UNITED STATES PATENT AND TRADEMARK OFFICE

| APPLICATION NO. | FILING DATE | FIRST NAMED INVENTOR | ATTORNEY DOCKET NO. | CONFIRMATION NO. | |
|-------------------------|-----------------------------|----------------------|---------------------|------------------|--|
| 10/612,229 | 07/01/2003 | James David Hensley | 10008165-4 | 4871 | |

DETAILED ACTION

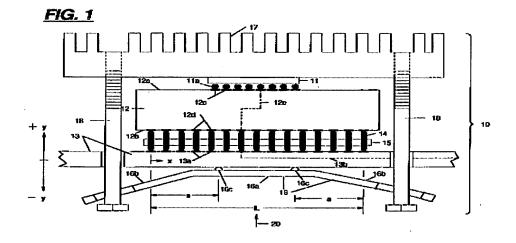
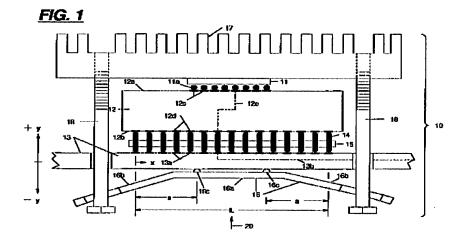
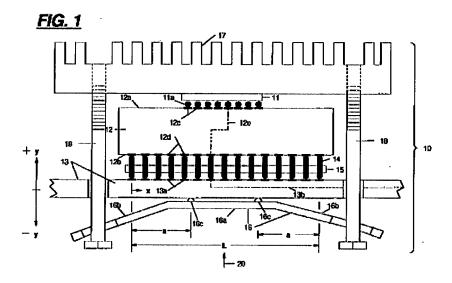
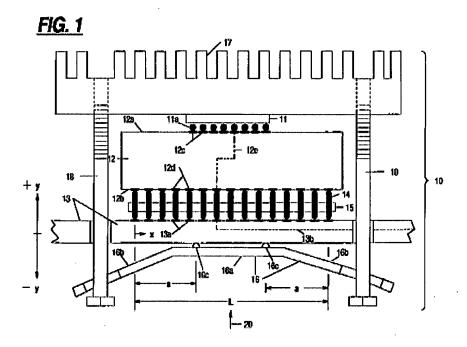
In re claim 1, <u>Tustaniwskyi</u> discloses a method to assemble a pre-curved bolster plate 16 to one side of a substrate 13 having a first side and a second side, comprising: attaching a component 15 to an electrical contact area 13a on said first side of the substrate 13; and attaching the pre-curved bolster plate 16 on the second side of the substrate 13, wherein the pre-curved bolster plate is attached to the second side opposite the electrical contact area on the first side of the substrate 13 (col. 3, line 2 to col. 4, line 4 and FIG. 1).

In re claim 5, <u>Tustaniwskyi</u> discloses wherein the pre-curved bolster plate **16** has a spherical curvature (FIG. 1).

In re claim 6, <u>Tustaniwskyi</u> discloses wherein the pre-curved bolster plate **16** has a cylindrical curvature (FIG. 1).

In re claim 21, <u>Tustaniwskyi</u> discloses a method for providing support substrate, the method comprising: attaching a component 115 to an electrical contact area 13a on a first side of the substrate 13; and attaching a pre-curved bolster plate 16 on a second side 16c of the substrate 13, the pre-curved bolster plate 16 having a pre-calculated radius of curvature prior to attachment to the second side 16c of the substrate 13 (col. 3, line 2 to col. 4, line 4 and FIG. 1).

In re claim 37, <u>Tustaniwskyi</u> discloses a method for coupling a plate member to an electrical packaging assembly, the method comprising: providing an electrical packaging assembly (11, 15); providing a plate member 16 that is pre-curved; disposing the plate member 16 against the electrical packaging assembly; flexing the plate member towards the electrical packaging assembly to produce a flexed plate member 16; and coupling the flexed plate member to the electrical packaging assembly (col. 3, line 2 to col. 4, line 4 and FIG. 1).

In re claim 38, <u>Tustaniwskyi</u> discloses wherein flexing comprises curving opposed ends of the plate member 16 towards a substrate 13 of the electrical packaging assembly (11, 14) (FIG. 1).

In re claim 40, <u>Tustaniwskyi</u> discloses wherein the electrical packaging assembly comprises an electrical component (11, 15) having a plurality of leads 14 attached to an electrical contact area 13a of a substrate 13 (FIG. 1).

FIG. 3

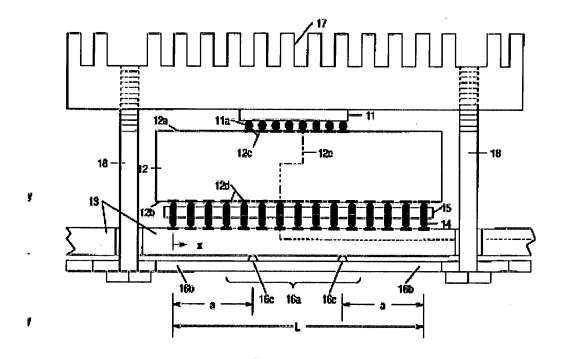
In re claim 58, <u>Tustaniwskyi</u> discloses wherein the radius of curvature is pre-calculated such that the pre-curved bolster plate 16 deflects into a flat plate (FIG. 3) after a clamping force is applied to the component which is assembled on the substrate 13 and to the pre-curved bolster plate 16 which is assembled on the substrate (col. 2, lines 26-34 and col. 4, lines 15-25).

In re claim 59, <u>Tustaniwskyi</u> discloses wherein the pre-curved bolster plate 16 has an entire surface that is in contact with the substrate 13 when a

clamping force is applied to the pre-curved bolster plate 16 and to the substrate 13 (FIG. 3).

In re claim 60, <u>Tustaniwskyi</u> discloses that the method of claim 1, further comprising: clamping the component and the bolster plate to the substrate (FIG. 3).

In re claim 61, <u>Tustaniwskyi</u> discloses that the method of claim 1, further comprising: clamping the component and the bolster plate 16 to the substrate 13 by use of a clamp (FIG. 3).

In re claim 71, <u>Tustaniwskyi</u> discloses wherein the radius of curvature is pre-calculated such that the curved bolster plate 16 deflects into the flat bolster plate after a clamping force is applied to the circuit member and to the curved bolster plate which is assembled on the circuit member (FIG. 3).

In re claim 72, <u>Tustaniwskyi</u> discloses wherein the curved bolster plate 16 has an entire surface that is in contact with the circuit member when a clamping force is applied to the curved bolster plate and to the circuit member (FIG. 3).
